UNITED STATES PATENT AND TRADEMARK OFFICE

APPLICATION NO.	FILING DATE	FIRST NAMED INVENTOR	ATTORNEY DOCKET NO.	CONFIRMATION NO.
10/561,353	12/19/2005	Norikazu Shinogi	CU-4615 RJS	9695
26530 7590 07/09/2008 LADAS & PARRY LLP 224 SOUTH MICHIGAN AVENUE SUITE 1600 CHICAGO, IL 60604				
EXAMINER				
HICKS, ROBERT J				
ART UNIT		PAPER NUMBER		
3781				
MAIL DATE		DELIVERY MODE		
07/09/2008		PAPER

Office Action Summary

DETAILED ACTION

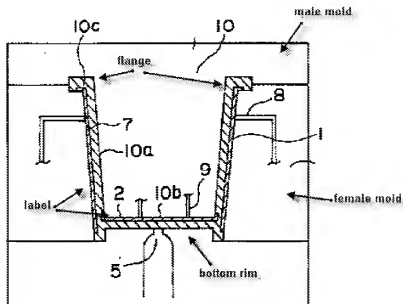
11. Regarding Claims 1-3, the publication to Shinoki – an in-mold label container – discloses an in-mold labeled plastic container [10, Paragraph 6 Lines 5-6, Paragraph 14 Line 1] fabricated by an in-mold labeling fabricating method [3, 4] by which molding of the container and labeling are accomplished at the same time by fitting an in-mold label [1, 2] into a gap [Fig. 1a], and injecting molten resin [7, Paragraph 8 Lines 5-8] into said gap, said gap being formed by using a female metal mold [3] and a male metal mold [4] and by joining said female mold and male mold [Fig. 1a]; the in-mold label container being characterized in a flange portion [10c] formed at the upper end of the side part of the container, and a bottom rim [10b] formed on the bottom part of the container [Fig. 2a], with the bottom rim labeled in the similar way to the side part of the container [Fig. 2a].

Shinoki does not expressly disclose that the flange has dimensions of 2 mm or more in flange width and 0.5 mm or more in flange thickness, or that the bottom rim has a dimension of not less than 0.3 mm but not more than 20 mm. However, the patent to Okabe – a plastic container made by molding – discloses a container [Okabe, 14] with a flange [Okabe, 15] and a bottom rim portion [Okabe, 14b], in which the flange could have a width ranging between 1.0 and 2.5 mm, and a thickness ranging from 0.2 to 1.0 mm [Okabe, Col. 24 Lines 15-17], and in which the bottom rim portion could appear to have a thickness between 0.3 mm and 2.0 mm [Okabe, Col. 10 Lines 6-9]. It would have been obvious at the time of the invention to one of ordinary skill, with known options available to one of ordinary skill within their technical grasp leading to anticipated success, to modify the dimensions of the flange and bottom rim portion in the Shinoki container to have a flange width more than 2.0 mm plus thickness more

than 0.5 mm, and a bottom rim with a dimension between 0.3 and 2.0 mm, as suggested by Okabe, since it has been held that discovering an optimum value of a result effective variable involves only routine skill in the art. See *In re Boesch*, 617 F.2d 272, 205 USPQ 215 (CCPA 1980).

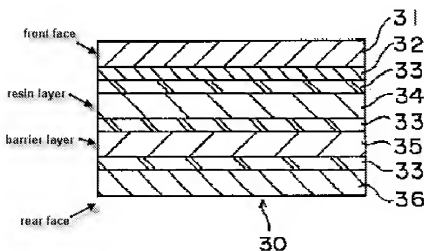
14. Regarding Claim 7, Shinoki in view of Okabe discloses all the limitations substantially as claimed, as applied to claims 1, 2, and 3 above, respectfully; further, Shinoki teaches the label [Shinoki, 1] is a label having a configuration [Shinoki, 30] in which a plurality of thin films are stacked, the thin film positioned on the front face [Shinoki, 31] and the thin film positioned on the rear face [Shinoki, 36] consist of thin films of the same material [Shinoki, Fig. 6], and further at least a resin film layer [Shinoki, 34] and a barrier layer [Shinoki, 35] having a defined strength or barrier layers having a defined strength are stacked between these thin films [Shinoki, Fig. 6]. The cross-sectional area of Figure 6 appears to show that the two outermost layers are made of the same material. See *MPEP* § 608.02 (IX).

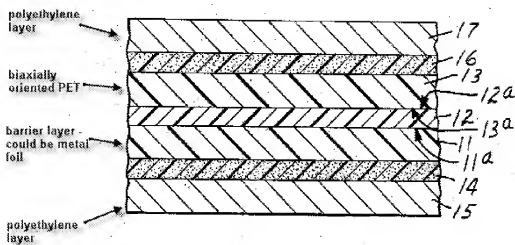
15. Regarding Claim 9, Shinoki in view of Okabe discloses all the limitations substantially as claimed, as applied to claims 1, 2, and 3 above, respectfully; further, Okabe teaches the fluid length (L) of the injected molten resin and the average wall thickness (t) of the container is: $L/t \leq 250$ [Okabe, Col. 10 Lines 3-9]. With the length of

the container appearing to be 55 mm, and the thickness appearing to be 1.1 mm, the ratio of the length to the thickness is approximately 50.
